## Technical Memorandum

To: James Clift (EGLE) and Ryan Mitchell (MDOT)	Project: Line 5 Pipeline
From: David Crouthamel, Sam Swartz, Jake Facey	cc: Marco Moccichino, Dan Adams
Date: January 13, 2021	Job No.: 6191.0
Subject: DRAFT Geotechnical Exploration Level of Effort for the Line 5 Replacement Tunnel

**Figure 1: Comparison of Enbridge Summary Document to Top of Soil/Rock encountered during drilling**

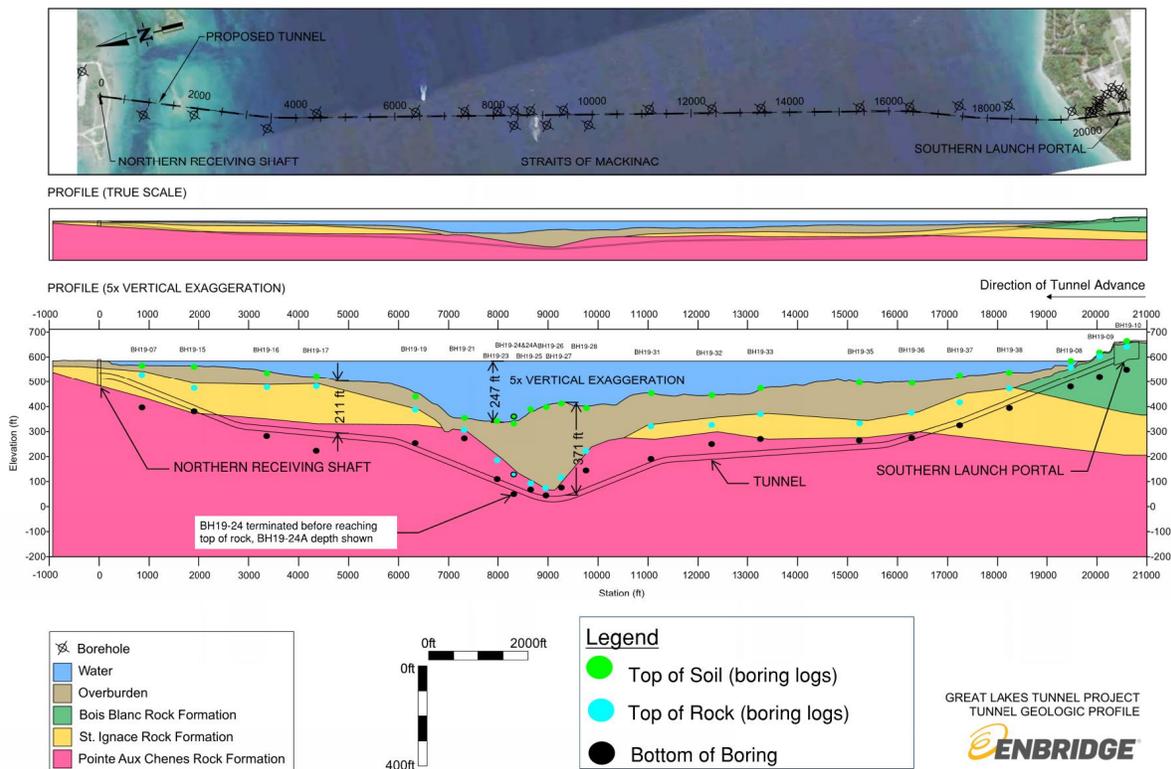
For the Enbridge summary document, in short it alone does not adequately characterize the anticipated ground conditions on site. It provides an overview of the number of borings and amount of testing as well as generally describing the anticipated rock formations. It also provides a profile of the tunnel alignment relative to rock formations. However, the document does not summarize the detailed findings of the investigation. In order to fully understand the ground conditions, it is important to view the data in relation to the vertical alignment, as well as methods anticipated to excavate the tunnel, in order to identify any high risk areas. The main risk anticipated in this crossing is the potential for high water inflows if highly fractured and permeable rock is encountered and not properly mitigated by either TBM excavation methods, or by pre-treating the ground ahead of the TBM. The severity of this risk is compounded by the high hydrostatic head and low rock cover in the middle of the crossing. Additional risks are instability of the rock at the face of the TBM, or from squeezing ground around the shield in weaker rocks. These risks are manageable in most tunneling projects, however the lack of available data at tunnel depth for portions of the alignment adds uncertainty to ground classification. This uncertainty

The figure reveals a large gap in borings that go to tunnel elevation between BH19-17 and BH19-36, which helps explain the difference in boring spacing when measured from the tunnel elevation vs the ground surface. See Section 3.2 for further discussion on comparison of this information to past comparable projects.

**Figure 2: Comparison of Recovery – by Rock Formation**

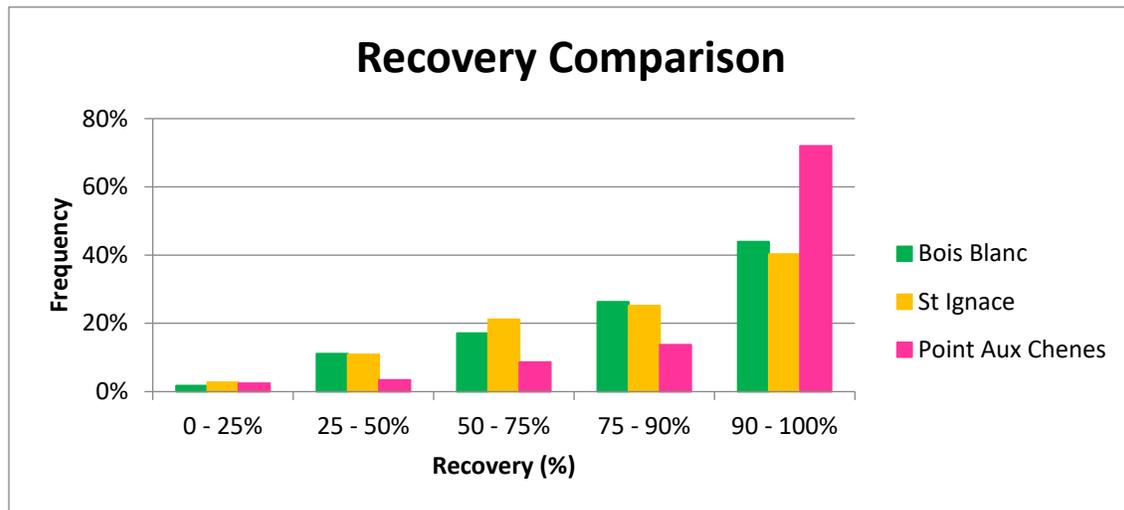
Recovery percentage is recorded while drilling and is useful when examining overall rock quality and for identifying potential voids in the bedrock. Figure 2 shows a histogram of all recovery values recorded during drilling, separated by rock formation. The data shows a higher potential for low recovery, which is indicative of poor quality rock, and/or open voids or heavily brecciated rock, in the St Ignace and Bois Blanc formations compared to the Pointe Aux Chenes. The impact of poor quality rock conditions on tunneling methods is discussed further in the document titled - *Collapse Potential for the Line 5 Replacement Tunnel* (January 2021).

Figure 3: Comparison of RQD by Rock Formation

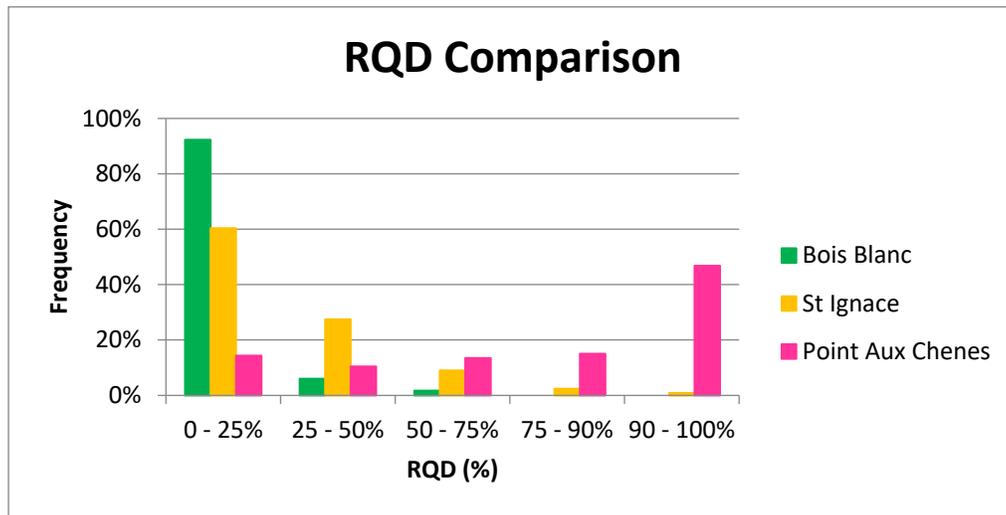
In general, the Bois Blanc rock is generally Very Poor; St. Ignace is Very Poor to Poor; and the Pointe Aux Chenes is quite variable, with most rock Fair to Excellent, but approximately 20 to 30% Very Poor to Poor as well.

**Figure 4: Hydraulic Conductivity along proposed alignment**

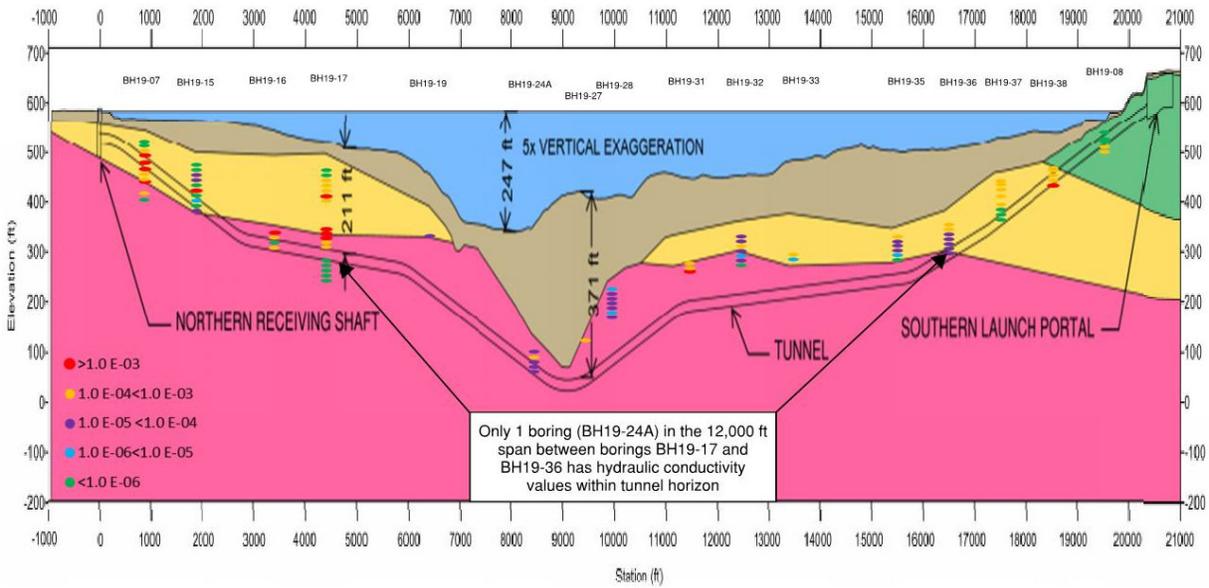
Much like the top of soil/rock plot, Figure 4 reveals significant absence of available data from within the tunnel alignment as BH19-24A is the only data point within the alignment over a span of approximately 11,000 ft. This lack of data corresponds to an inherent risk in tunneling, and has the potential to be exacerbated by the high hydrostatic head within this span. It should be noted that, due to the limits of the testing apparatus, packer testing has an upper limit of  $10^{-3}$  cm/s so it is possible that higher hydraulic conductivity values are present along the alignment. A further discussion of this risk, including impacts and potential mitigation techniques, are discussed in the white paper titled *Risk Mitigation for the Line 5 Replacement Tunnel*. (January 2021).

**Figure 5: Hydraulic Conductivity along proposed alignment**

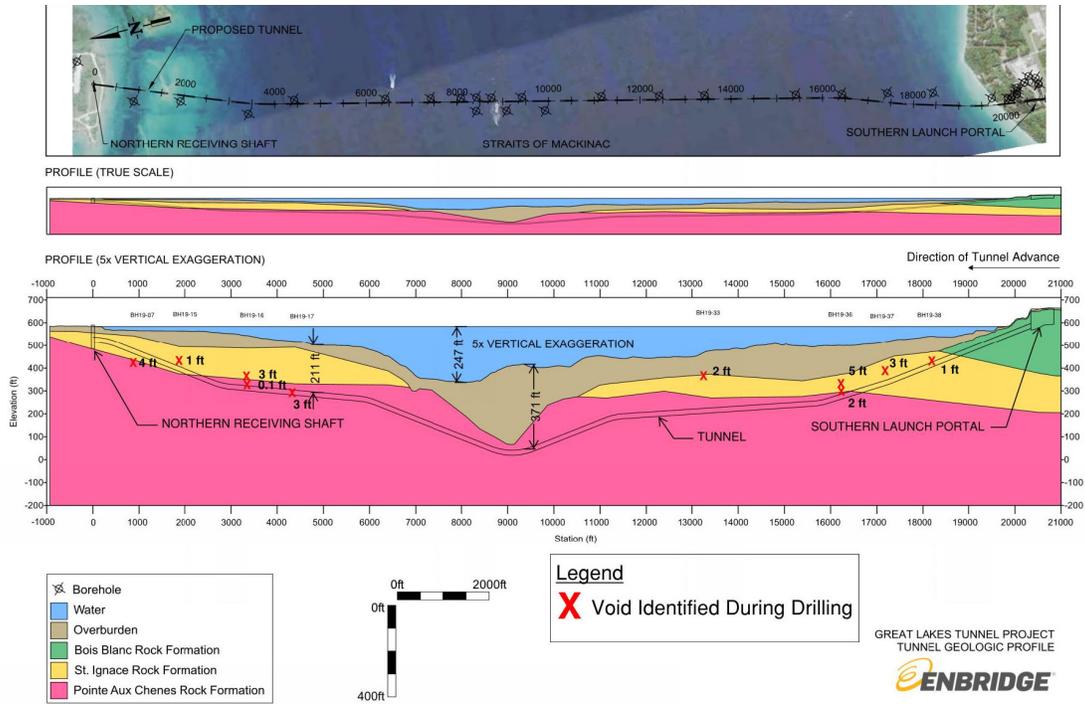
Figure 5 above notes 10 instances of “voids” due to poor core recovery identified during drilling, however it is likely that more of these conditions exist in the spans between borings. Also, it should be noted that most of the brecciated rock exist within the St Ignace formation, however there were some zones discovered in strata identified as Pointe Aux Chenes. When tunneling, it is important to either mitigate conditions by use of a fully pressurized TBM, or to identify and mitigate these areas. Failure to control inflows during open interventions can result in unmanageable groundwater inflows, slower advance rates, and ground loss which, in the worst cases, can significantly impact progress and overall water inflows into the tunnel. The white paper titled: *Collapse Potential for the Line 5 Replacement Tunnel* (January 2021) offers a more detailed discussion of the design challenges associated with brecciated or open seam fractured rock conditions.
